PREVOST

WARRANTY BULLETIN

WB17-14 A

DATE :	May 2017	SECTION :	06 ELECTRICAL
EXPIRATION:	May 2019		
SUBJECT :	INSPECTION/REPLACEMENT OF ALTERNATOR POWER CABLE STUD ADAPTER

Figure 3

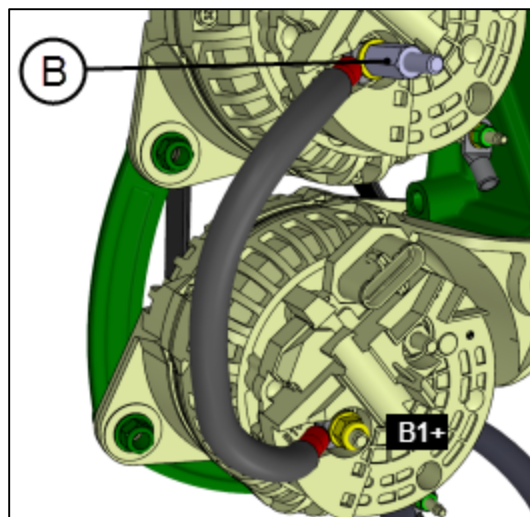
3. Clean the anti-corrosion compound that was applied on the stud adapter **B** especially between flats.

Figure 4

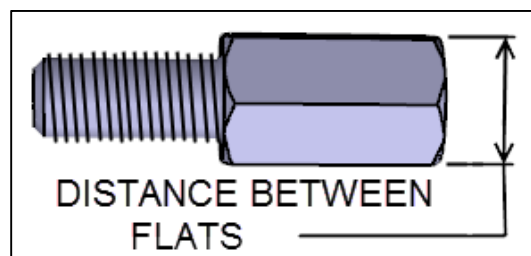
4. Inspect the distance between flats on the stud adapter. There are only two possibilities; 1/2" or 5/8".
5. First, use a 1/2" open wrench and check if you can engage the wrench between the flats of the stud. If you cannot engage the 1/2" open wrench on the stud, try a 5/8" open wrench and check if you can engage this second wrench between the flats of the stud and if it fits tight.

6. If the distance between flats is 5/8", you have the correct stud. Move to step 7.

If the distance between flats is 1/2", you have the wrong stud and you need to change it. Move to step 10.

Figure 7

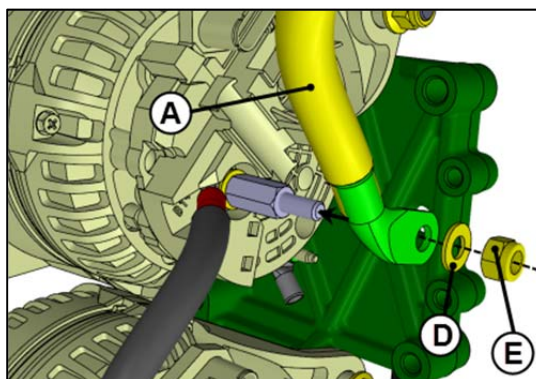
7. Reinstall power cable **A**. To do so, connect power cable **A** to the stud adapter, install the flat washer **D** and the new locknut **E**.
8. **Protect the alternator stud and cable terminal against corrosion.** Apply anti-corrosion compound or **Color Guard Rubber Coating** on the stud adapter, the cable terminal, and the locknut.
9. Bulletin is complete.

E: LOCKNUT M8 #5001787 (*torque: 10 lbf-ft*)

FIGURE 8

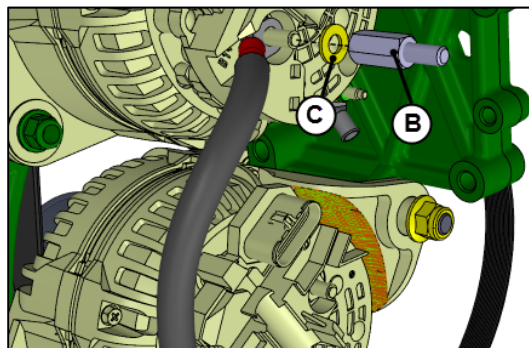
10. Remove old stud adapter **B** (FIGURE 8).
11. Before installing the power cable, make sure that the nut that secures the alternator stud is properly tightened (FIGURE 9).
12. Install appropriate new stud adapter **B**. Make sure the jumper cable terminal and the flat washer **C** are still in place (FIGURE 8).

B : STUD ADAPTER #060297 (torque: 10 lbf-ft)

FIGURE 10

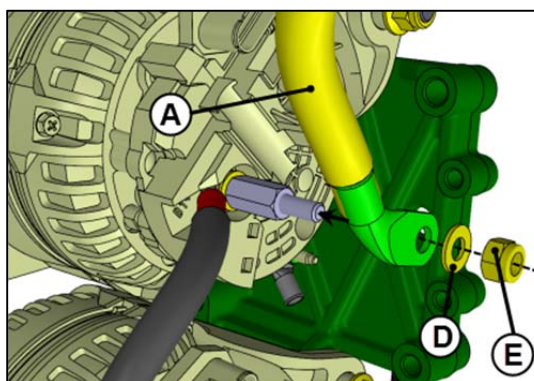
13. Reinstall power cable **A**. To do so, connect power cable **A** to the stud adapter, install the flat washer **D** and the new locknut **E**.
14. **Protect the alternator stud against corrosion.** Apply anti-corrosion compound or **Color Guard Rubber Coating** on the stud adapter, the cable terminal and the locknut.
15. Bulletin is complete.

E: LOCKNUT M8 #5001787 (torque: 10 lbf-ft)
